Request for Quotation

RFQ NUMBER
 DEFK7045

LINE	QUANTITY	UOP	CAT NO	ITEM NUMBER	UNIT PRICE	AMOUNT
***** ADDENDUM NO. 1 ***** ADDENDUM ISSUED TO DISTRIBUTE THE PRE-BID SIGN-IN SHEET FROM THE MANDATORY MEETING HELD 08/15/06 FOR THE DUNBAR NATIONAL GUARD ARMORY ROOF REPLACEMENT PROJECT, AS WELL AS THE COMMENTS, QUESTIONS/ANSWERS, AND A REVISED DRAWING AS A RESULT OF THE MEETING. BID DATE AND OPENING TIME REMAIN UNCHANGED AS 09/06/06 AT 1:30 PM. ***** NO OTHER CHANGES *****						
0001	1	LS		770-93		
	EPDM ROOF REPLACEMENT

Dunbar National Guard
Armory

ADDENDUM DRAWING

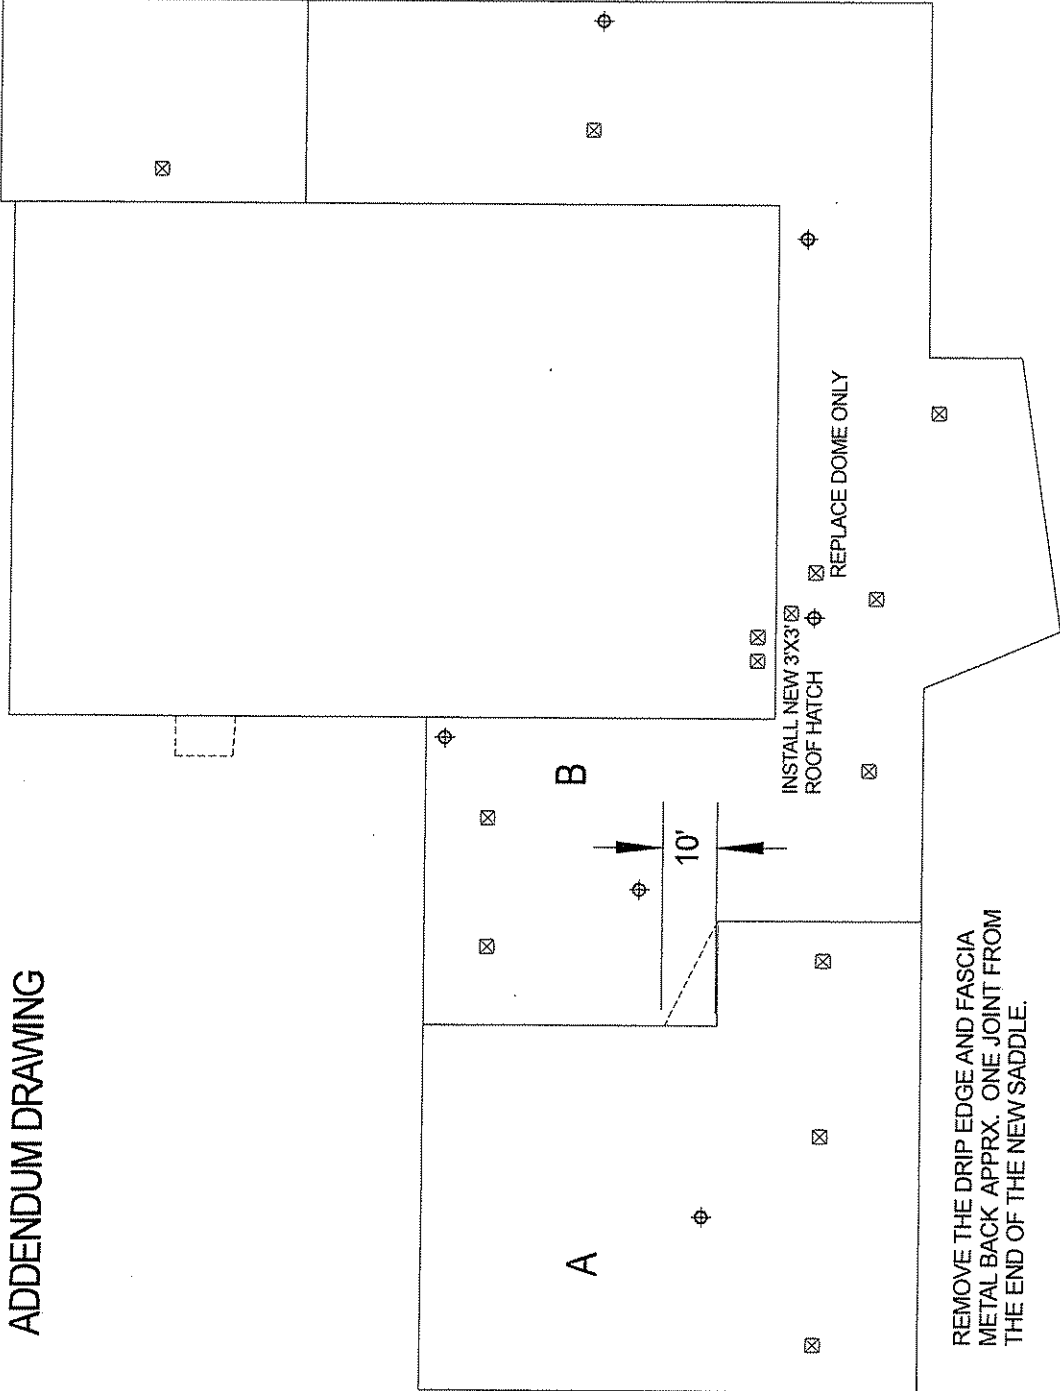
- 1) CHANGE IN THE SCOPE OF WORK, AREA (DRILL HALL).
INSTALL NEW TARGET PATCHES AT ALL DRAIN AREAS AND STRIP IN ALL CURB FLASHINGS.
- 2) USE 6" CLEAN CURED PRESSURE SENSITIVE EPDM ON ALL FIELD SEAMS AND 9" PRESSURE SENSITIVE OVERLAYMENT STRIP ON ALL METAL TO BE REPAIRED.
- 3) ALL DOWN SPOUT THAT IS REMOVED WILL BECOME THE PROPERTY OF THE OWNER AND LEFT ON THE PREMISES.
- 4) ADD THE ENTRY CANOPY ON THE DRILL HALL TO THE SCOPE OF WORK FOR FULL TEAR-OFF AND RE-ROOF TO FOLLOW ADMIN. AREA SPECIFICATIONS.

- 1) INSTALL NEW .032 MILL FINISH ALUMINUM DRIP EDGE STYLE DETAIL AS A REPLACEMENT FOR THE 24GA. KYNAR THAT WAS ORIGINALLY SPECIFIED. FOLLOW SMACNA AND ROOF MEMBRANE MANUFACTURES GUIDELINES.
- 2) INSTALL NEW 3'X3' ROOF HATCH AT THE LOCATION SHOWN ON THE ATTACHED ROOF PLAN. ALUMINUM COVER AND CURB.
- 3) INSTALL NEW SKYLIGHT DOME AT THE LOCATION SHOWN ON THE ROOF PLAN. MILL FINISH FRAME WITH CLEAR OVER WHITE GLASS.
- 4) AREAS A AND B ARE DESIGNATED ON THE DRAWING AND THE LOCATION OF THE NEW SADDLE IS DESIGNATED. REMOVAL OF THE EXISTING EDGE DETAIL IS REQUIRED IN THESE AREAS AND A CONTINUOUS PIECE OF EPDM WILL JOIN THE 2 ROOF AREAS.
- 5) REMOVE ALL EXISTING TURBINE VENTS DURING TEAR-OFF.

REMOVE THE DRIP EDGE AND FASCIA METAL BACK APPRX. ONE JOINT FROM THE END OF THE NEW SADDLE.
